RE: Mercado Village
1-GP-2024
H3682 (Key Code)
1-ZN-2024
6K913 (Key Code)

Thank you for providing these comments for review. The following is our responses to staff's second review comments regarding the above referenced case.

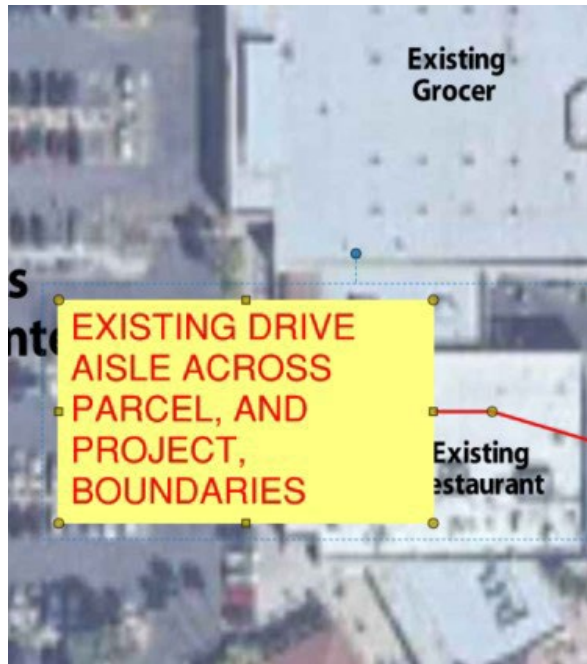
2. In accordance with DSPM 2-1.303, please address how the 24-foot-wide drive aisle and 6-foot-wide sidewalk will be maintained around the existing neighboring parcel's building and provide letter of

intent from that parcel owner of them granting an easement for your use over their land to meet your development's requirement accordingly. It appears from the available context information that the corner of the existing building is likely to encroach the proposed drive aisle:

Response: Attached to this resubmittal is an older, signed version of an agreement that addresses this issue. We are currently in the process of updating this agreement with this zoning case with the adjacent property owner. Also, as referenced in the first response above, please refer to the maintenance of open areas on the property from the existing recorded amended and restated declaration of establishment of restrictions and grants of easements between the Mercado property and Sprouts/Chompies Center. We have attached a truck turning graphic to this resubmittal that we sent to the adjacent property owner to demonstrate how the new drive aisle works and truck movement around the corner of the building that will remain on the adjacent property.
